# Pine Point Residents Association

**Association Response to  
Traffic Consultant William Bray's  
Report to the  
Beach Access Task Force  
February 2010**

**MEMORANDUM**

**SUBJECT:** Pine Point Beach Access Improvement Plan

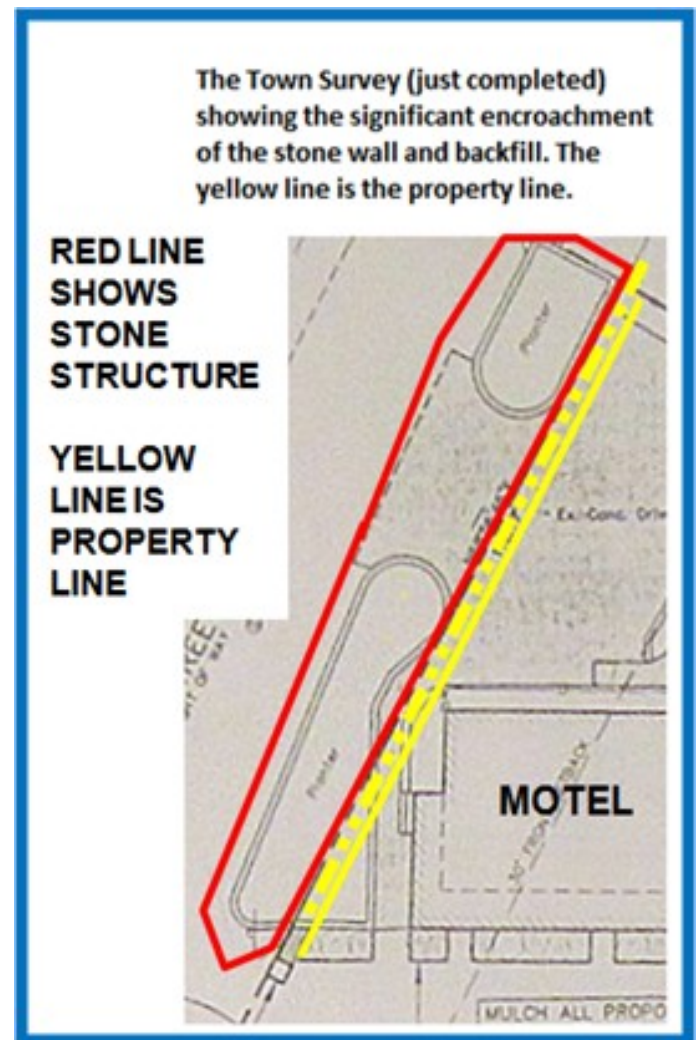
Mr. Bray did not specifically address the questions posed by members of the public at the forums regarding removal of the encroachment of the stone wall structure in the right-of-way. Several residents' positions were that removal of the encroachment would enhance pedestrian safety regardless of any other improvement in this area because its presence forces pedestrians to walk in that section of King Street just after the curve. Bray's reference to "visual delineation aids" is unclear, but the question from residents related to the extent to which removing the encroachment would make for a more practical and safer drop-off plan as shown later in this report.

Residents believe removal of the structure would open up a significant area of the right-of-way and provide safer drop-off and maneuvering back on to King Street (see red arrows showing the wall gone and a more gradual return of cars on to King Street. It also affords the opportunity to continue the sidewalk-esplanade design.

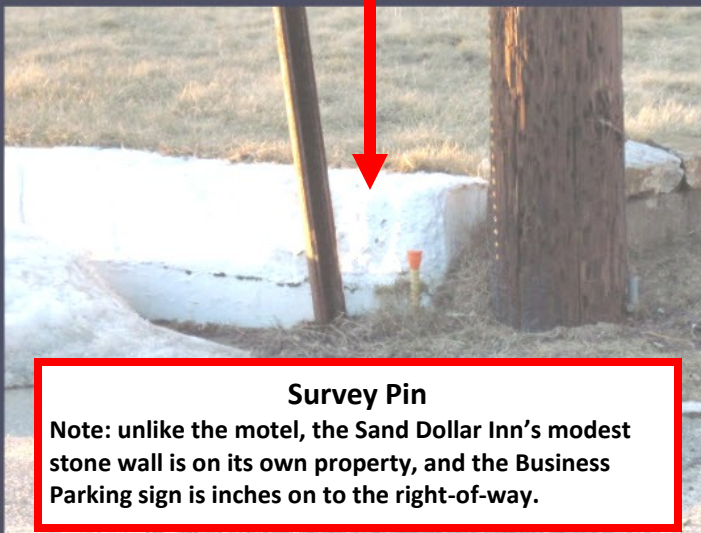
Finally, Bray's conclusion (#5) regarding the business parking sign across from the Truman's stone wall encroachment (see next page) just reinforces residents' opinions. He wrote **"King Street is a somewhat narrow roadway; on-street parking on either side of the streets... certainly has a negative impact on both vehicle circulation and roadway safety."** Since this sign is directly across from the stone wall encroachment, it begs the question why Mr. Bray would recommend removal of a sign for short-business parking (which has existed for many years) but not removal of a substantial structure, 90% of which is within the right-of-way and causes the "narrow roadway" he is concerned about. It is also very unfair to penalize one business while allowing another to benefit from using public land for private purposes.

***NOT a typical encroachment common in the Town's rights-of-way. This structure is not a tree or bush, a small picket fence or set of mailboxes. It is a stone wall, backfilled and landscaped... almost entirely on Town Land.***

## Rendering of King Street showing Wall Structure Encroachment Removed

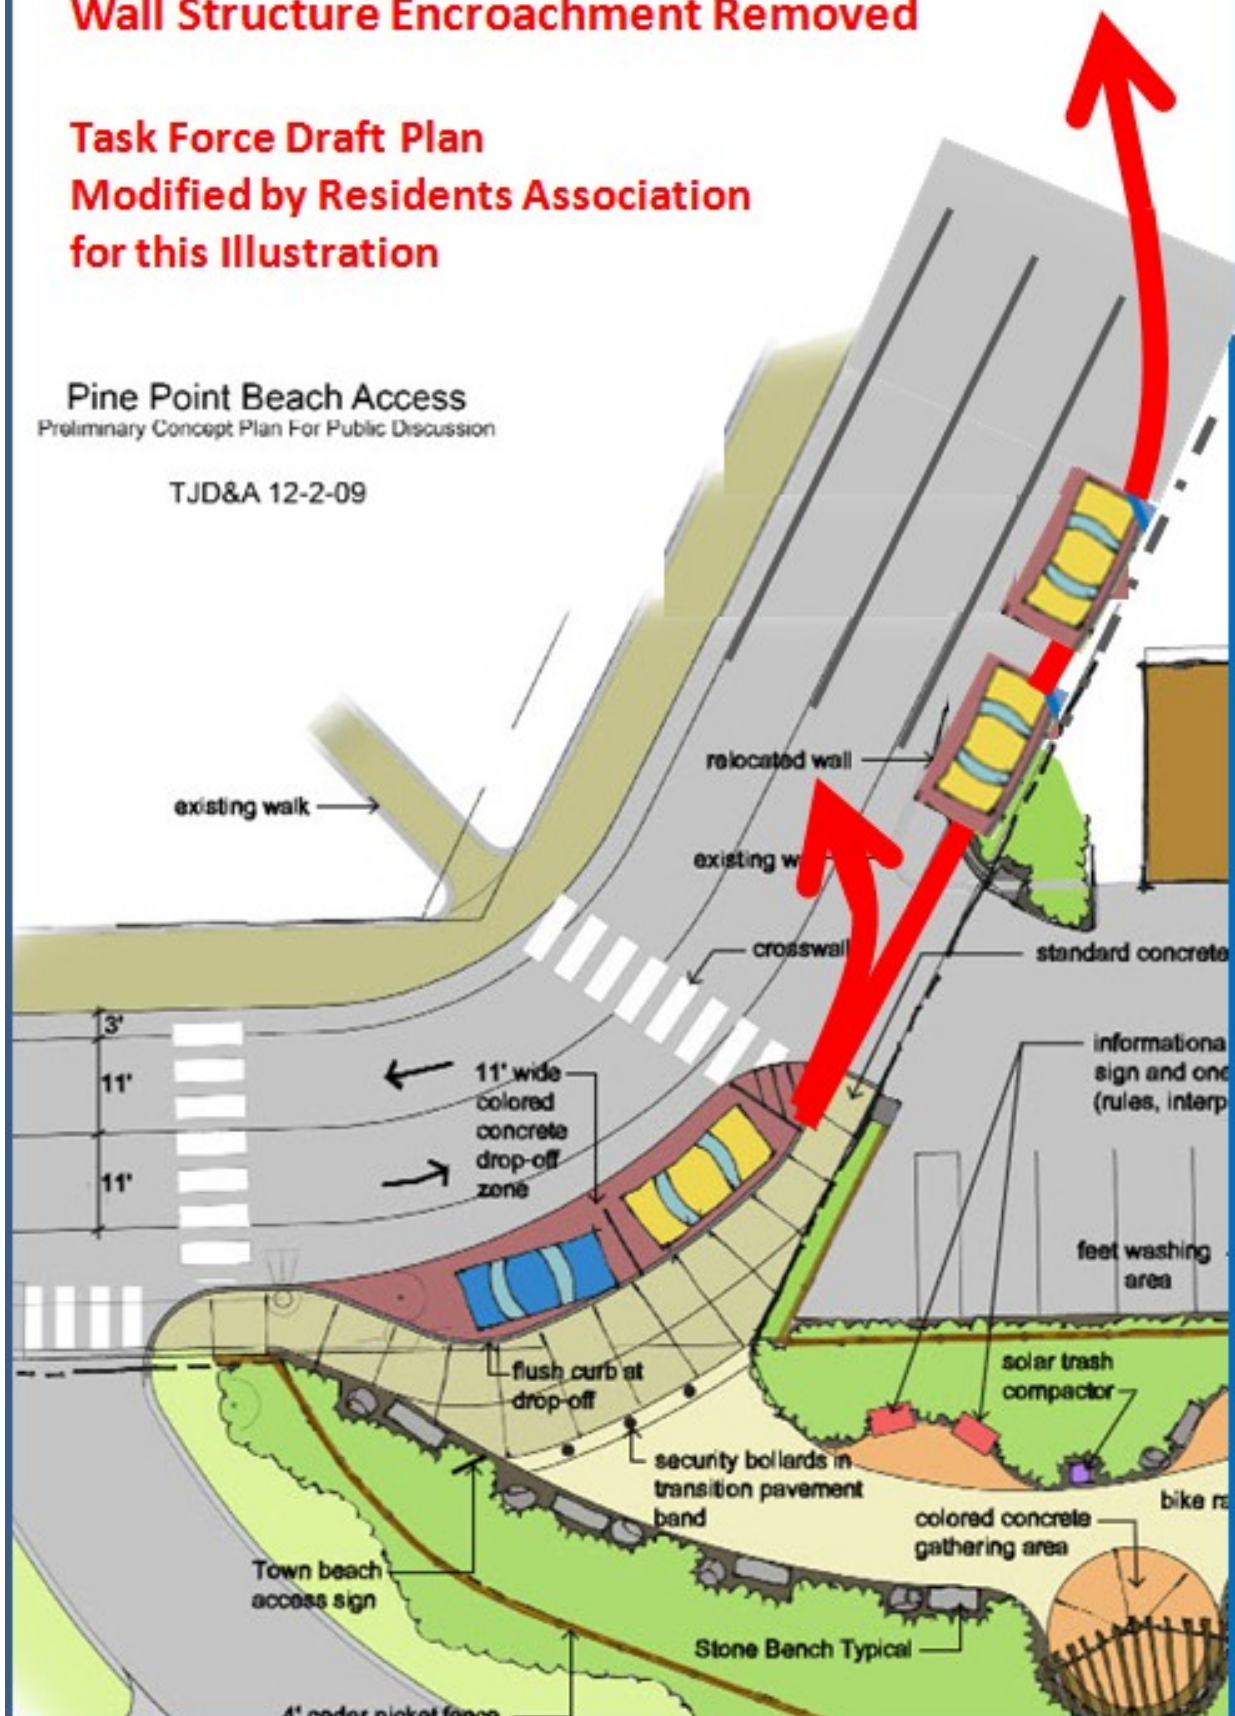
Removal of Stone Structure From the Street to the Property Line (yellow line) will open a large area of the right-of-way which has forced pedestrians into the street for years. It will also facilitate a safer drop off and potential for extending the sidewalk-esplanade design.
